Title: Advisory Committee on Reactor Safeguards
 Regulatory Policies and Practices

Date: Monday, September 16, 2013

- ACRS comments on MACCS2 weather uncertainty integration and convergence of results, and staff responses
- MELCOR parameters of interest
- MACCS2 parameters of interest

MACCS2 and Weather Uncertainties for LCF Risk 2

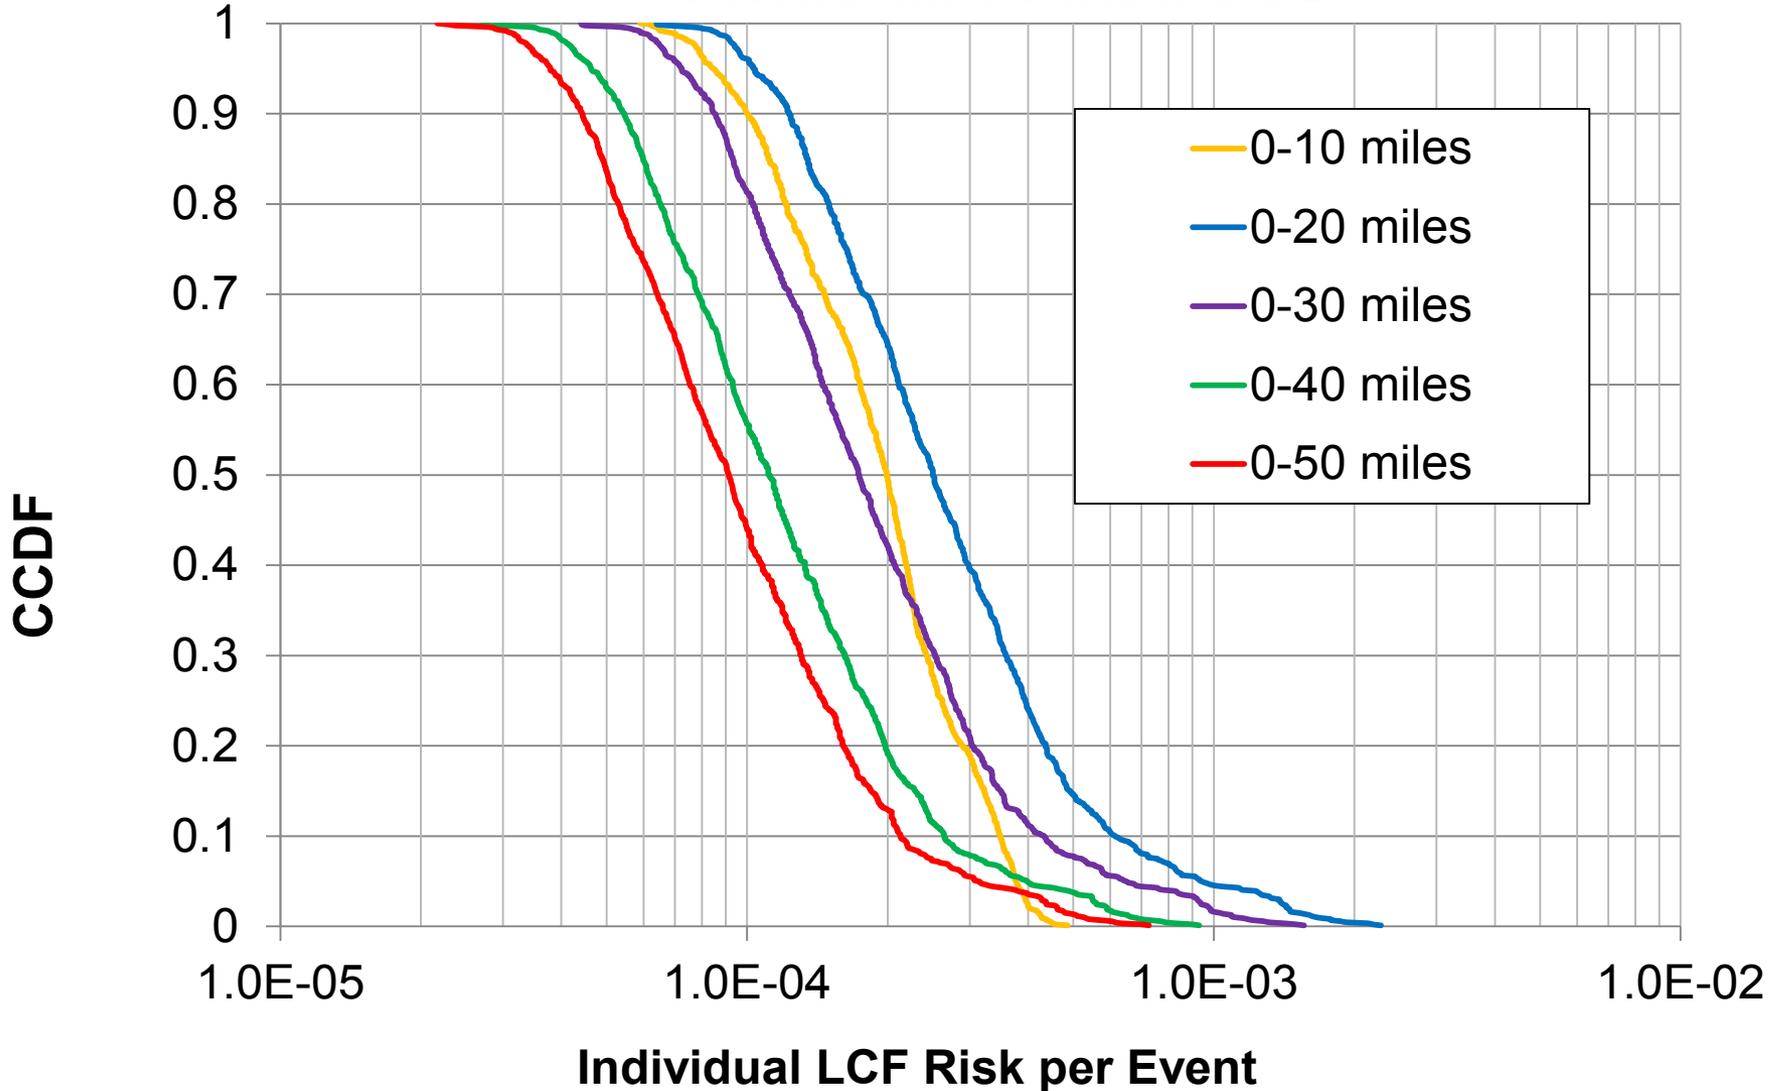
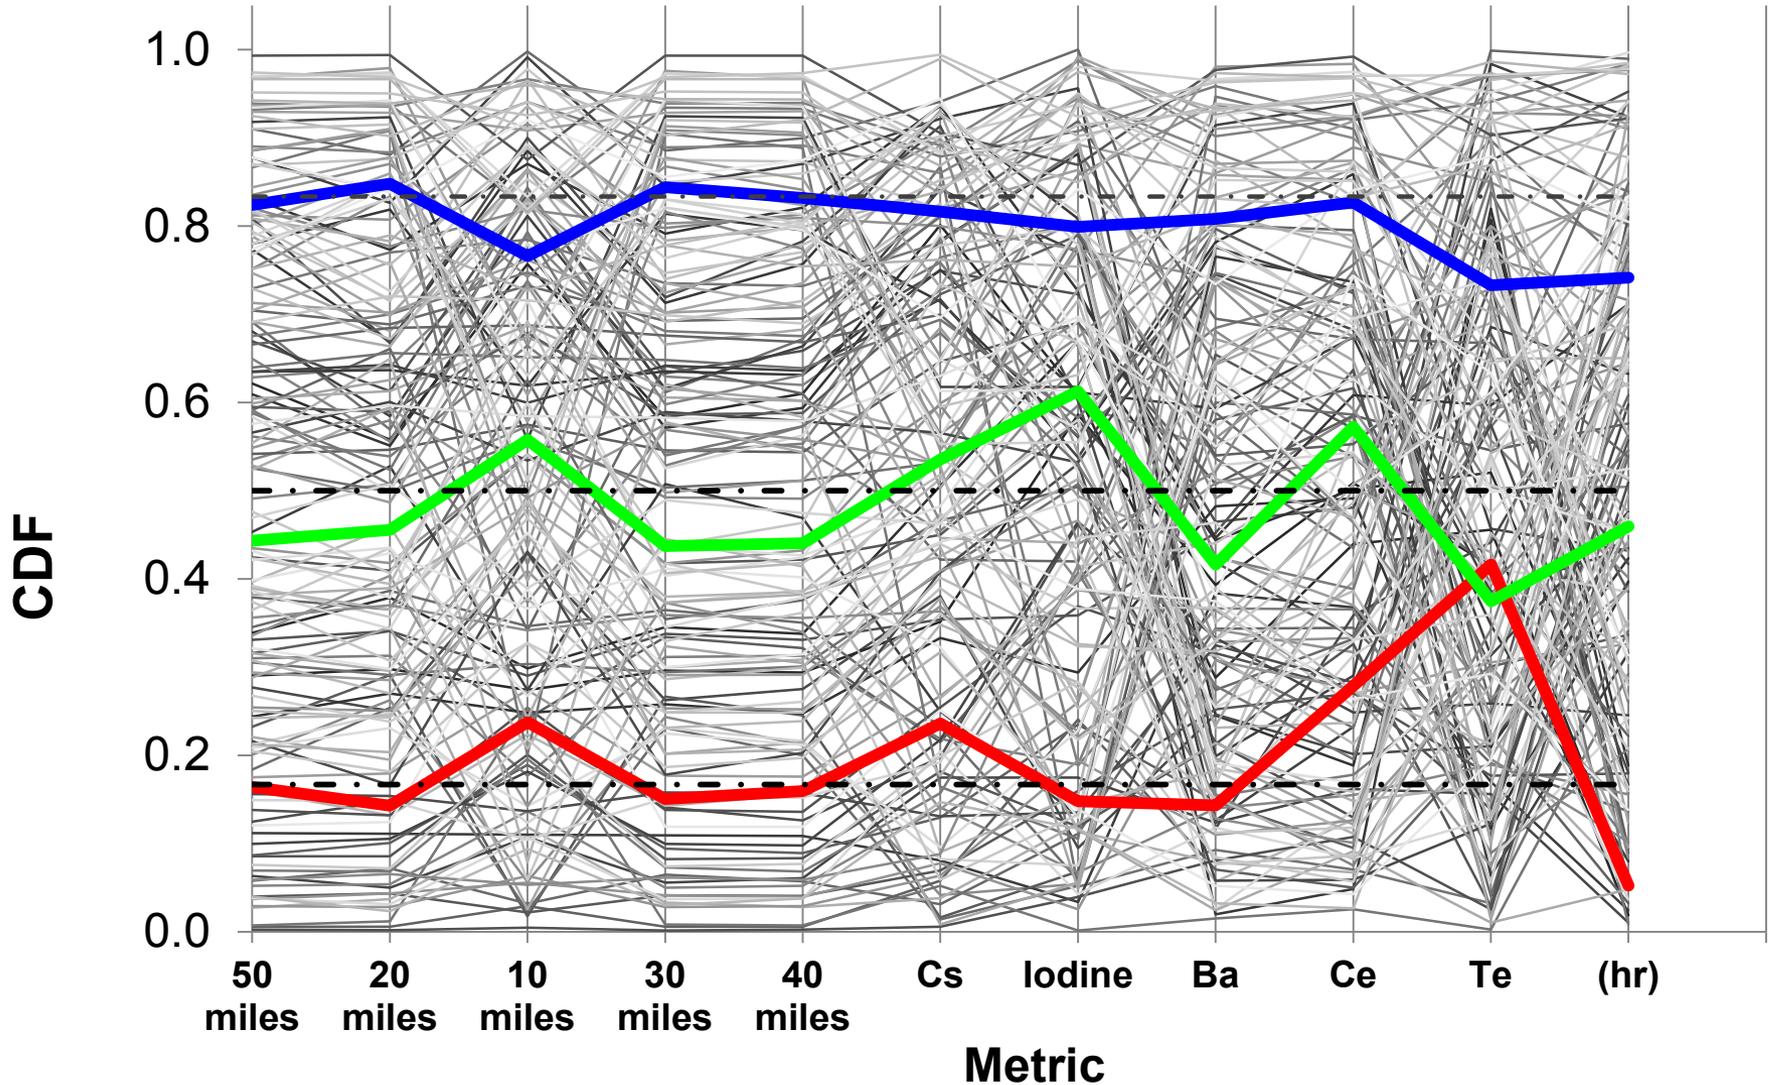
ACRS Comment:

- Select a MELCOR realization that produced a small, but non-zero, contribution to the conditional LCF fatality consequences in the current SOARCA uncertainty results.
- For that realization, sample from the 350 MACCS2 input parameters, and for each epistemic sample generate 984 weather cases to derive an uncertainty distribution for the conditional LCF fatality consequences at each distance.
- Demonstrate convergence of the combined MACCS2-weather uncertainty analysis results.

- A set of 11 results have then been used as metrics to select three representative source terms:
 - Latent Cancer Fatality (LCF) risk at 5 different locations (10, 20, 30, 40 and 50 miles)
 - Fraction of inventory released for 5 radionuclides (Cs, I, Ba, Ce, Te)
 - Release time
- Goal is to choose three source terms whose metrics' ranks come closest to $1/6$, $1/2$, and $5/6$ among the population

Run 1 (CAP17) Conditional, Mean, Individual LCF Risk (per Event) CCDF with LHS and MC Sampling

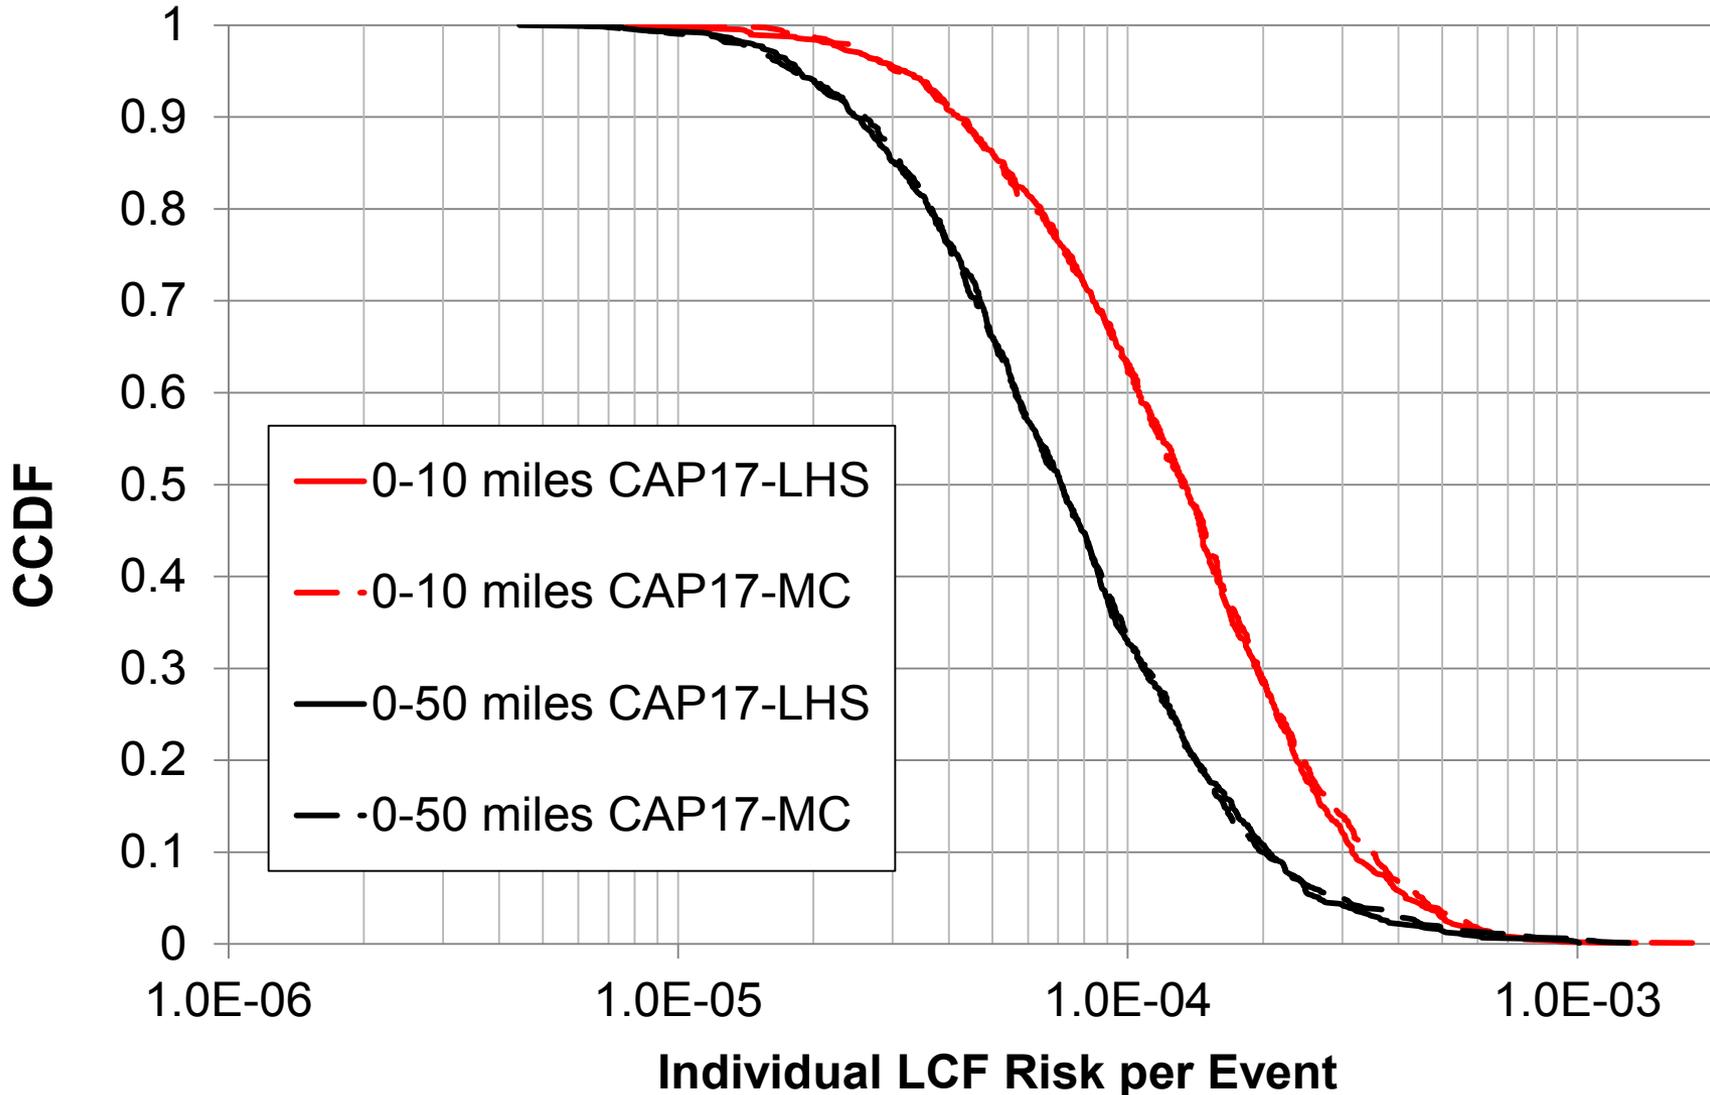
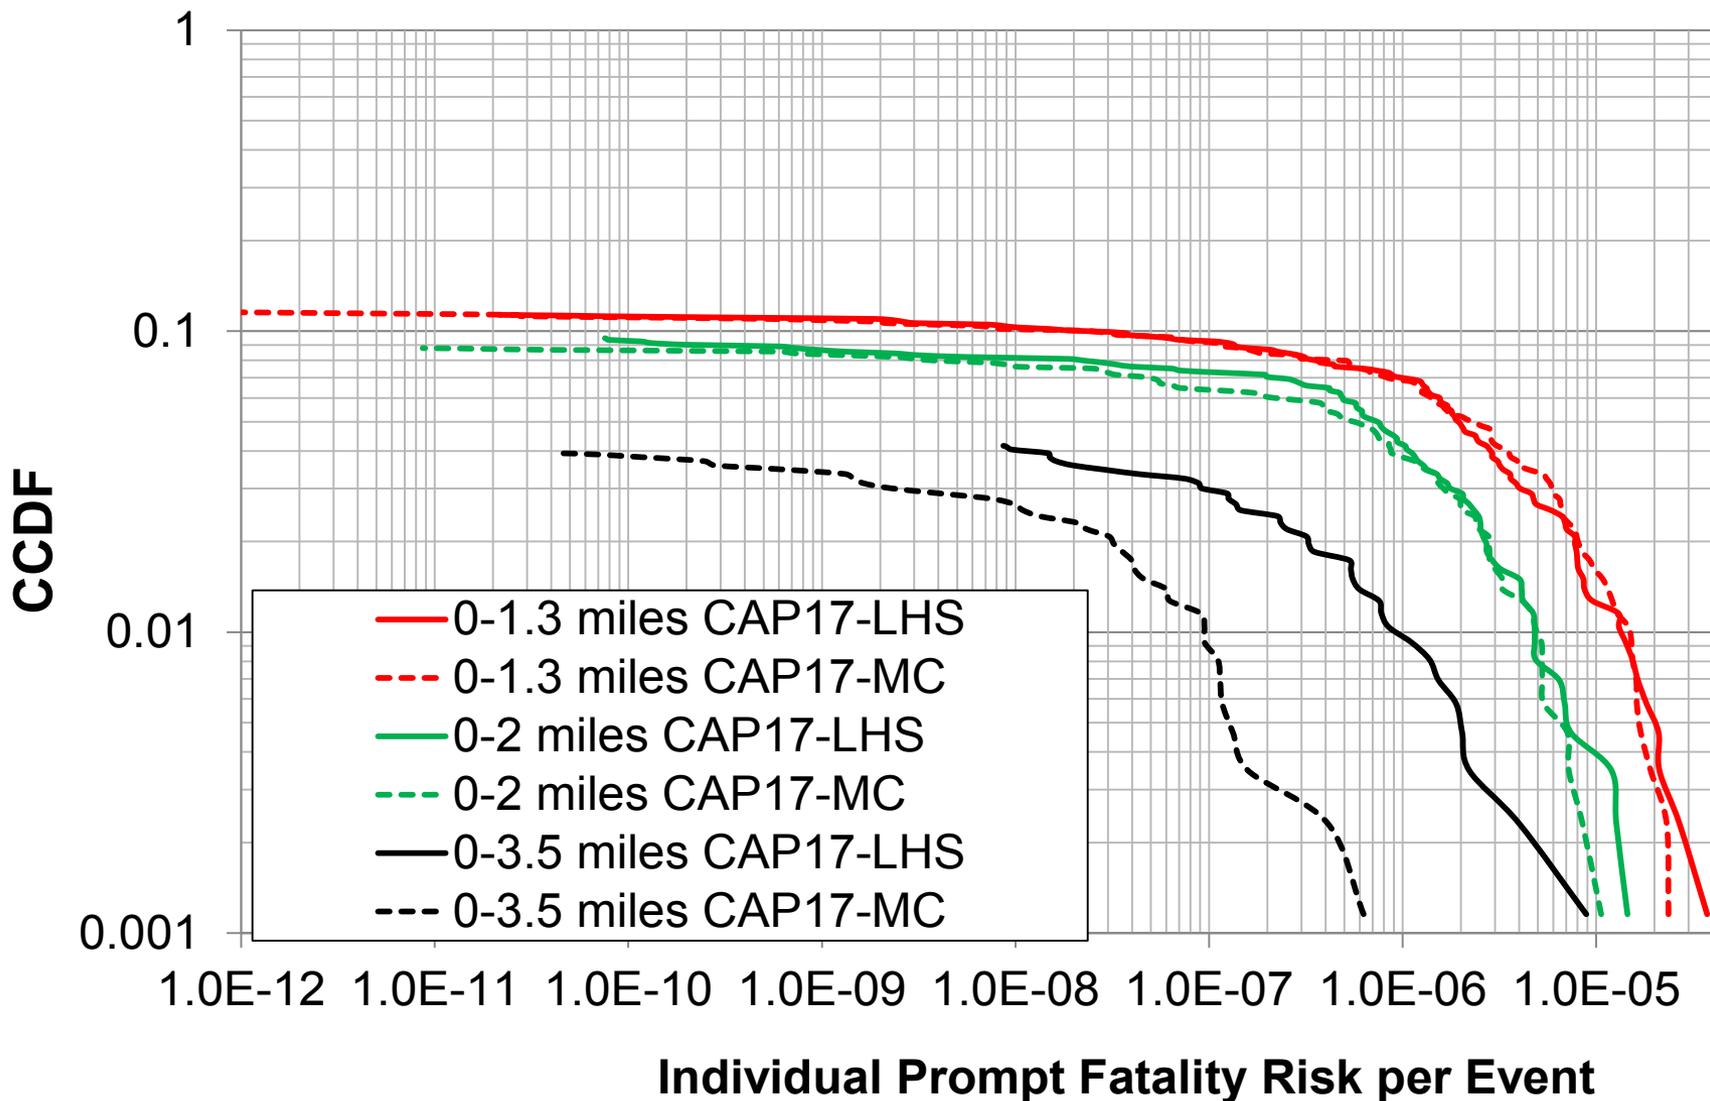
19 DR. GHOSH: So the question came up a lot
20 in the past discussions - some of it online, some of it
21 offline - about why do we keep using Latin hypercube
22 sampling and, you know, I guess one school of thought is
23 not very fond of Latin hypercube sampling.

Approach:

- MACCS2 code modified to allow simple random sampling
- The ‘high’ source term (i.e., Replicate 1 Realization 290) and the SOARCA UA MACCS2 Analysis (Run 1) were selected to compare between Simple Random Sampling (SRS or MC) and Latin Hypercube Sampling (LHS) in order to validate the use of LHS
- Bootstrapping performed (similar to approach with MELCOR results) to estimate confidence bounds
- Conclusion: Results of the uncertainty analysis are well converged and LHS use is valid
